Enclosed is the Final Action Statement on the 2021 Wildfire Mitigation Plan (WMP) Update of Southern California Edison Company (SCE).

FINAL EVALUATION OF 2021 WILDFIRE MITIGATION PLAN UPDATE SOUTHERN CALIFORNIA EDISON

SCE's 2021 WMP Update is approved.

Figure 1: SCE's Ignitions Against Risk Buydown⁹⁸

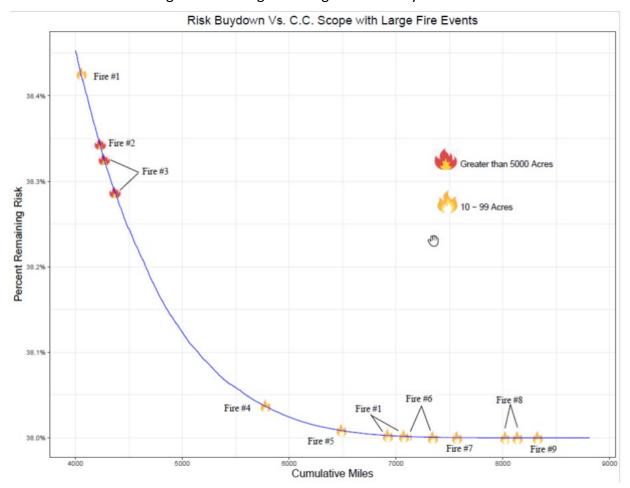
SCE justifies its extensive plan for covered conductor with a graph (see Figure 1 below) showing that destructive wildfires have recently occurred in SCE's service area on circuit-segments located in areas "further down the risk buydown curve that would remain uncovered under a more limited deployment scenario." ^{93,94} However, SCE does not provide enough information to adequately demonstrate the need for covered conductor for circuits ranked as lower risk by SCE's own risk ranking. For one, SCE does not identify the cause of each ignition, thereby making it impossible to determine if covered conductor would have prevented or reduced the likelihood of the ignition from occurring. This omission is particularly relevant given that SCE calculates that covered conductor installation reduces risk by only 64% and does not account for all ignition drivers.⁹⁵ SCE also fails to acknowledge that the majority of ignitions within SCE's service territory are caused by third-party contacts,⁹⁶ as covered by SCE-21-10 in Section 5.1. Lastly, the graph is based on SCE's previous risk model, used in 2020. While SCE states that "the concepts remain unchanged and valid,"⁹⁷ SCE must reassess risk based on its current risk assessment model including consequence, introduced in 2021, and reflect upon the accuracy of model outputs if actual risk is occurring beyond its own cumulative risk mile assessment. This is addressed in SCE-21-05 in Section 5.3.

⁹⁴ Figure SCE 9.10-1 of SCE's 2021 WMP Update - Redlined shows that two fires greater than 5000 acres and 7 fires 10-99 acres in size occurred beyond the 2,110 cumulative mile risk ranking

SCE- 21-05	Out-dated risk assessment used to justify the selection and scope of covered conductor as a mitigation initiative	SCE provides a risk buydown curve based on its old modeling efforts to justify the need for covered conductor. SCE acknowledges that its current models provide different and more accurate results but does not provide an updated risk buydown curve. SCE should not use outdated information to justify its covered conductor program scope. Additionally, if an updated risk buydown curve	 SCE must: 1. Provide an updated Figure 9.01- 1 based on SCE's latest risk modeling assessment, including the ignitions shown. 2. Provide the cause of the 9 ignitions shown in Figure 9.01-1. 3. For each of the nine ignitions shown, provide an assessment of the likelihood that covered conductor installation would have prevented the ignition.
